## User interface changes

Software version v1.0 Sara Plus PCB

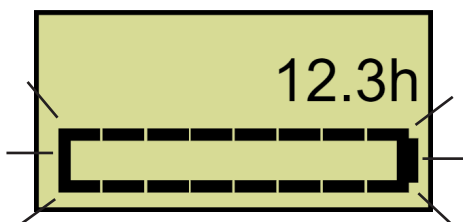
If, during movement, the battery indication drops from high charge to one or zero bars, the battery is starting to deteriorate (it can still be used till fully discharged). Replace and fully charge the battery.

Note that the buzzer indication of empty battery has been shortened to two seconds after all buttons release.
